# PROCESS CHANGE NOTIFICATION PCN0903

# ALTERNATIVE ASSEMBLY SITE FOR THE EPC CONFIGURATION FAMILY

Figure 2. Date-Code traceability for the Country of Origin

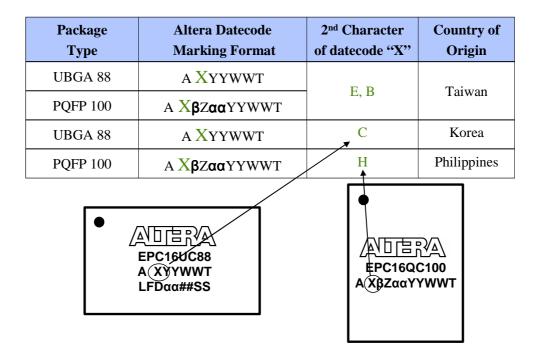
This change is scheduled to occur no earlier than December 2009. The product will transition to the new material as the current inventory is consumed. Customers may receive products with this change beginning with a date-code marking of 0949 or later on the top of the package. See Figure 1. The 0949 date-code marking indicates the earliest date that the new material may be used for any of the affected devices. Figure 2 shows the date-code traceability for country of origin.
